DATE: JULY 1992

REF: JD 08/92

## ERRATA

Fig 1

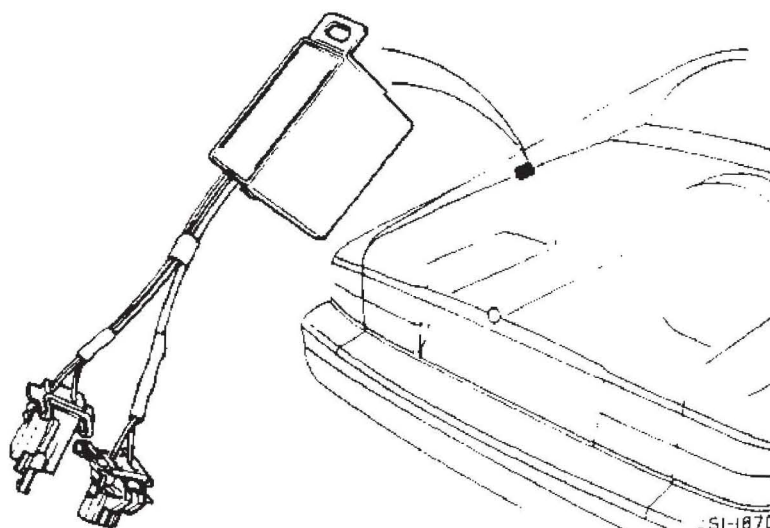
MODEL : XJS 4.0 LITRE MODELS ONLY  
SUBJECT : SPEED INTERFACE MODULE  
CUSTOMER CONCERN : Fuel Fail (FF) Code 68 registering at speeds in excess of 90 mph (144 kph).  
ADVICE TO CUSTOMER : A new interface module is now available and should be fitted to resolve this concern.  
DEALER ACTION : Yes  
REPAIR METHOD : Speed interface module – renew (XJS 4.0 litre only).  
\* Open the boot  
\* Disconnect the battery negative lead  
\* Remove the LH side trim panel  
\* Locate the speed interface module secured to the relay mounting bracket (See Fig. 1.)

- \* Remove the module and replace with new interface module, Part No. DAC 11375
- \* Replace the trim panel
- \* Reconnect the battery negative lead
- \* Close the boot

Note: DAC 11375 replaces DAC 7474 on all XJS models from the introduction of 1993 M.Y., VIN 185820.

FIG 1

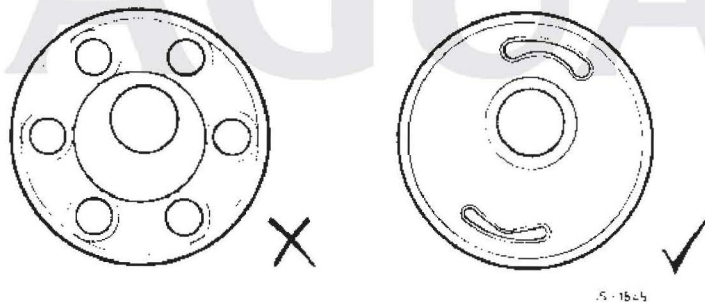
**Note:** The bushes originally used were termed as 'six-shooter' bushes. These have now been redesigned / replaced by the 'smiley-faced' bushes currently being used, see Fig. 1 for identification.

FIG. 1

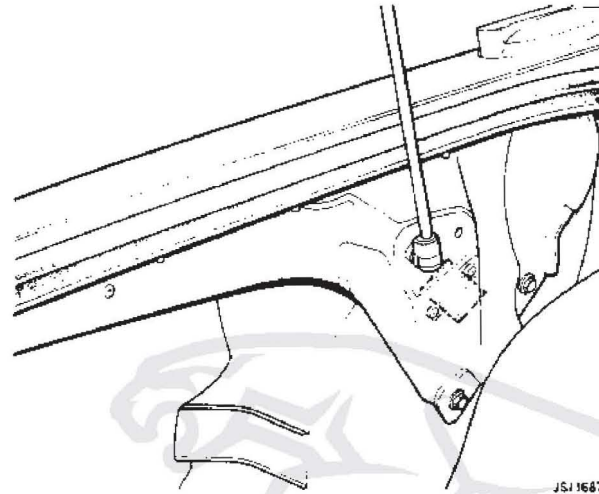
From VIN 179737 (92MY Facelift XJS), the stop light failure sensor module is located in the boot of the vehicle, attached to the inside of the boot side reinforcement panel (drainage channel) L.H. (Fig. 1).

FIG. 2

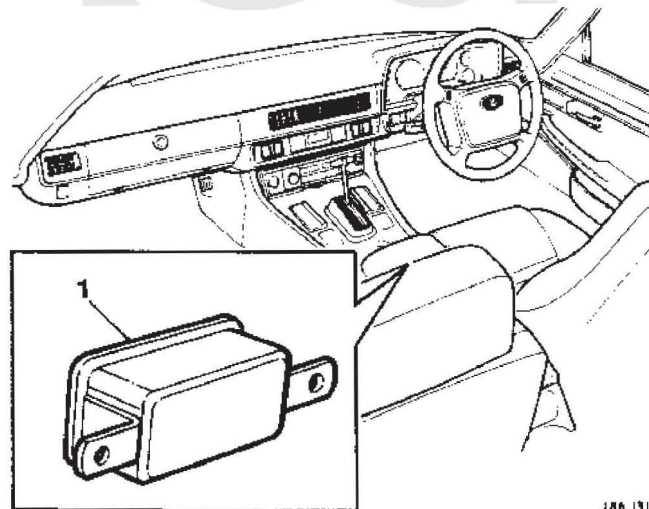
Prior to VIN 179737 (90MY XJS), the module is located beneath the centre console veneer finisher, attached to a bracket in front of the stowage compartment (Fig. 2).
